Subject: **SBWR Test Program**

Reference: Purdue Testing Meeting, GIRAFFE Testing Program RAIs,
October 1, 1993

Requests for Information by Purdue University prior to
meeting on October 1, 1993.

GE ANSWERS TO PURDUE UNIVERSITY QUESTIONS ON SBWR SYSTEMS

ATT. 4

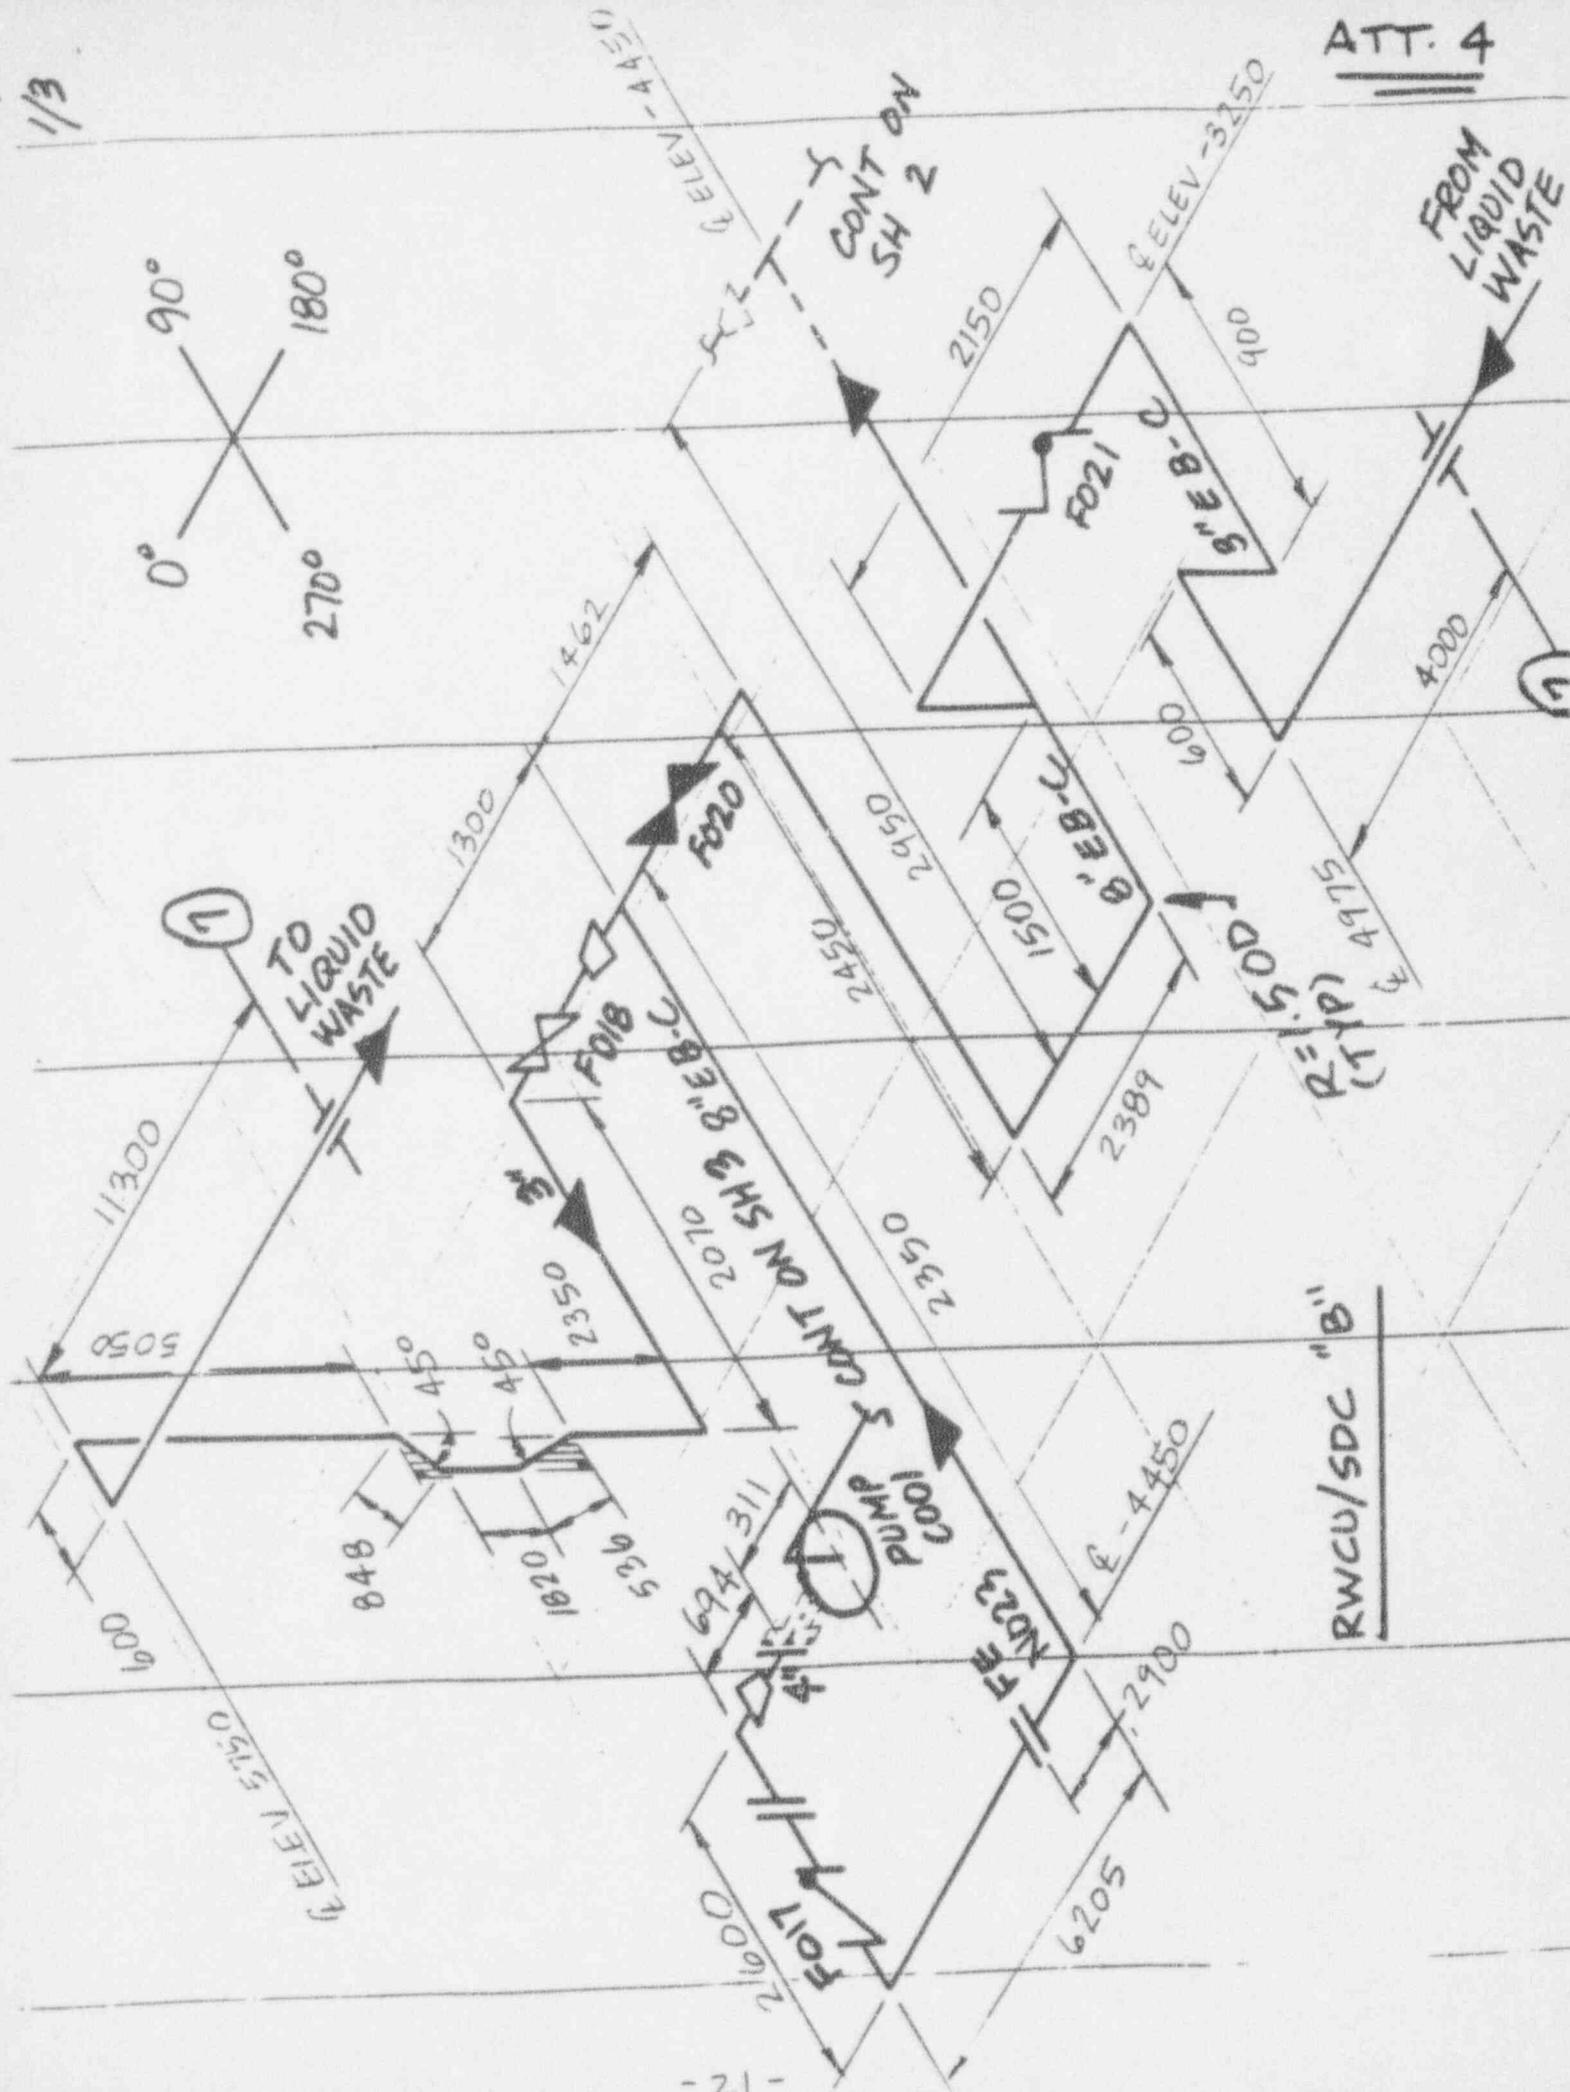
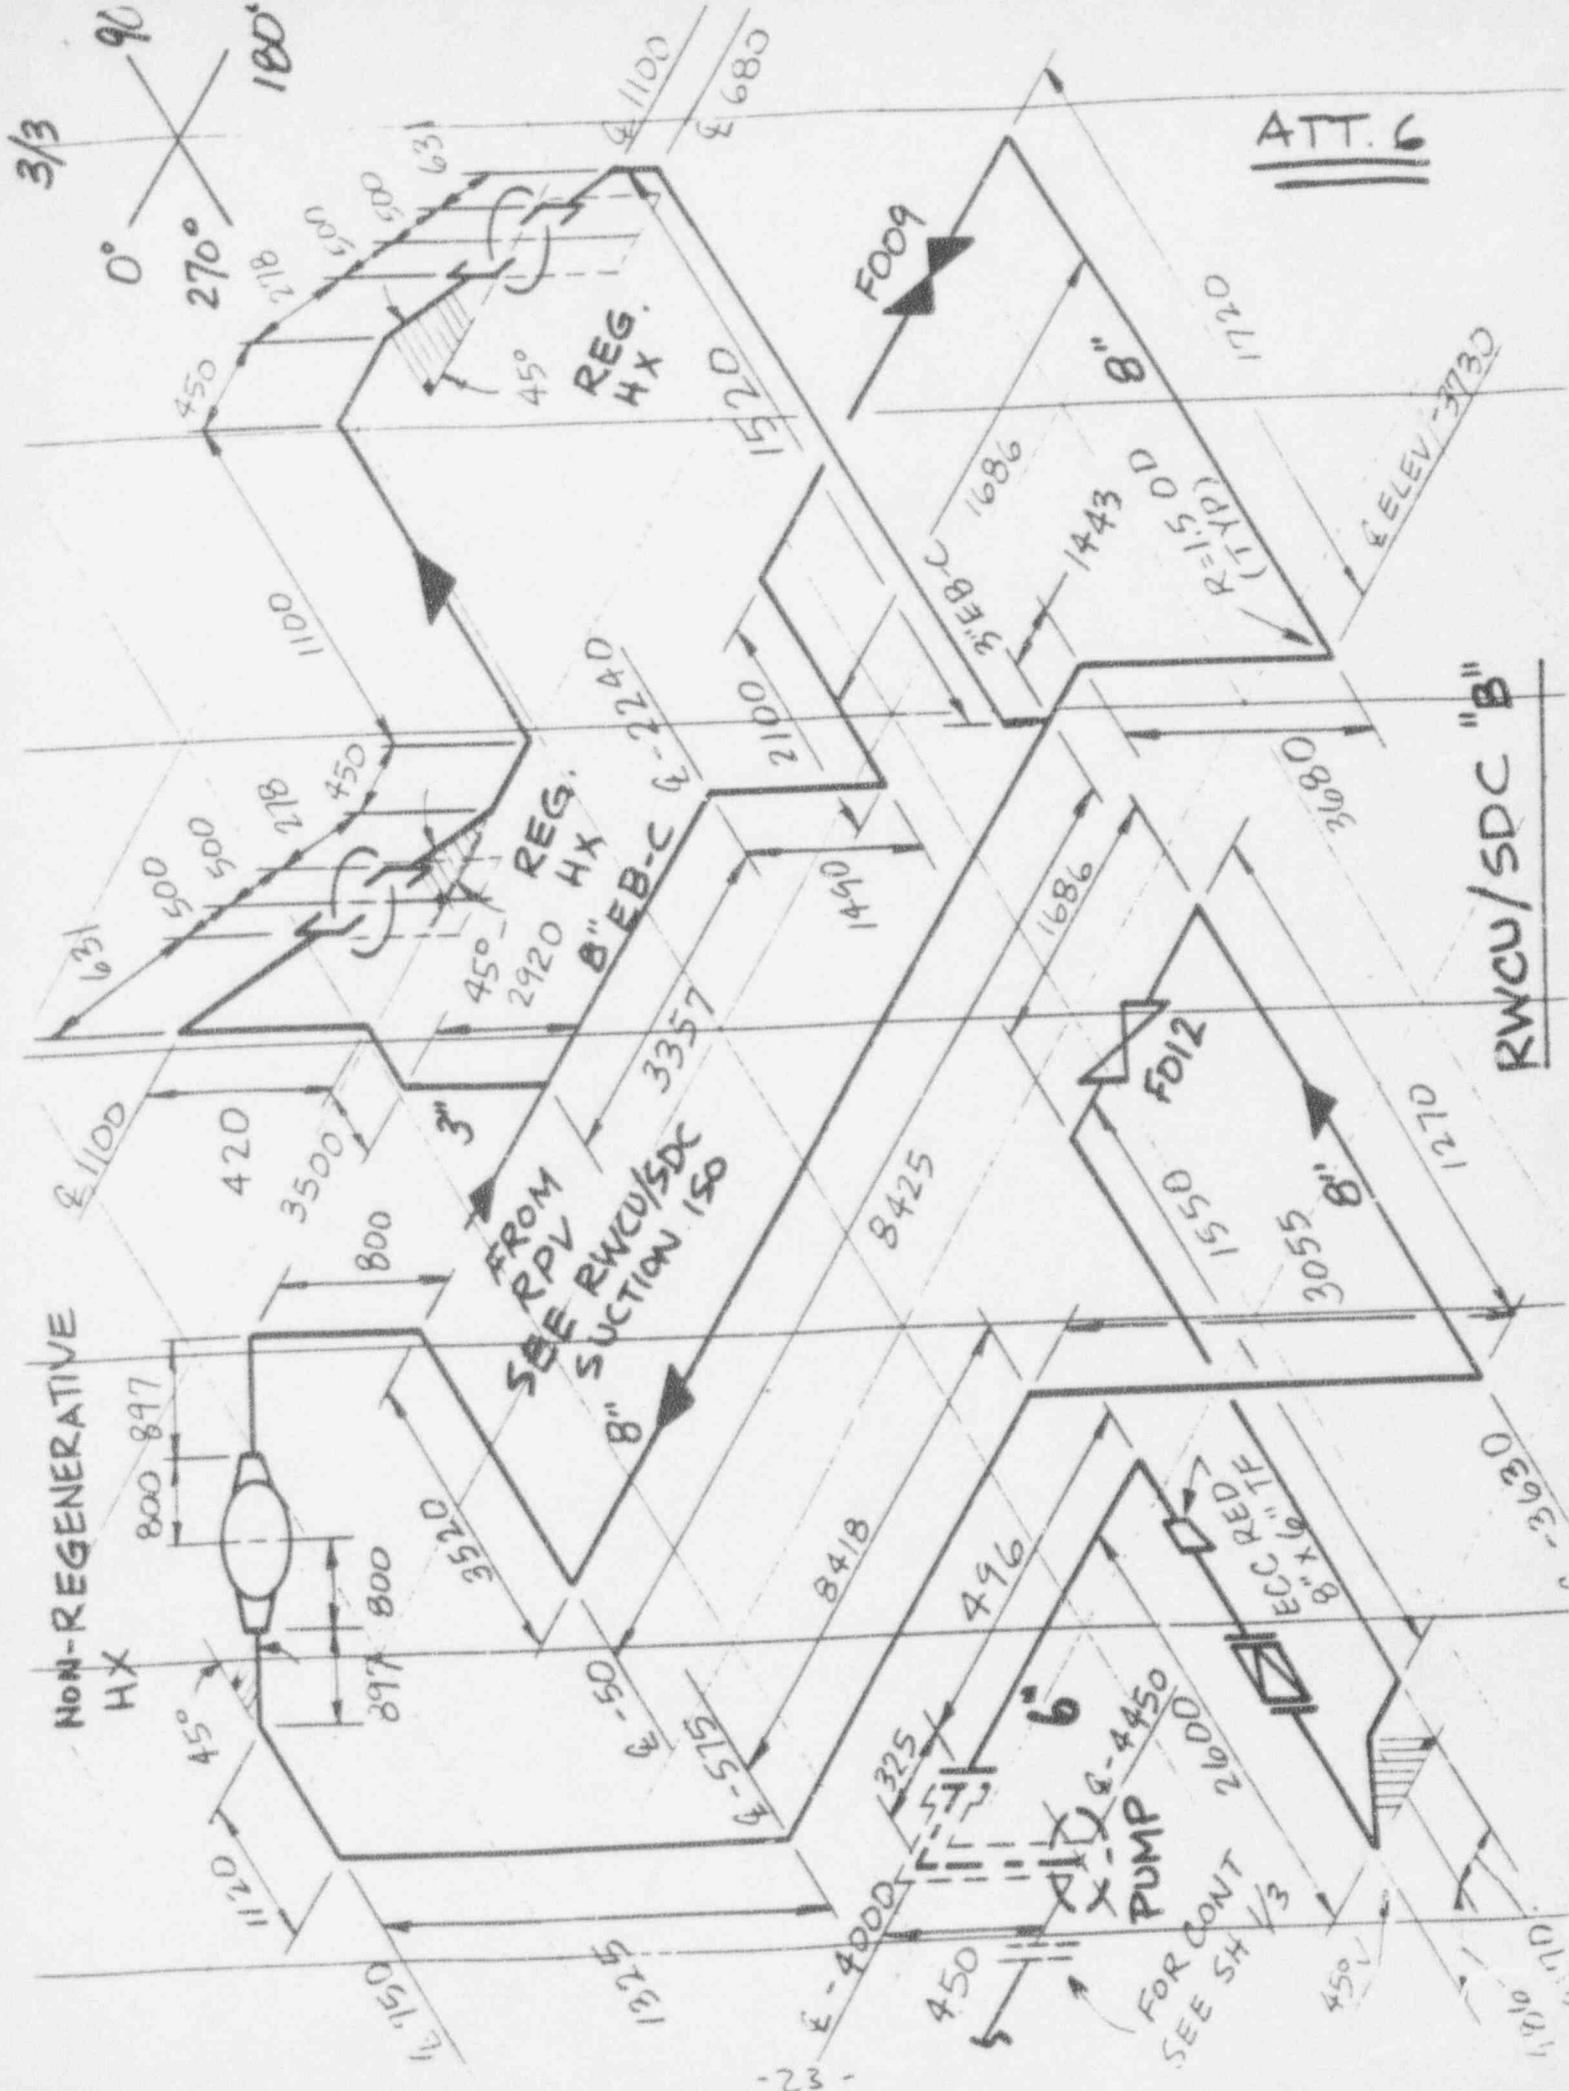
6. Need isometric drawings for pipings of the following auxiliary systems :
- a. Reactor water cleanup system/Shut Down System
 - b. Control Rod Drive System

- a. RWCU/SDC system drawings attached.
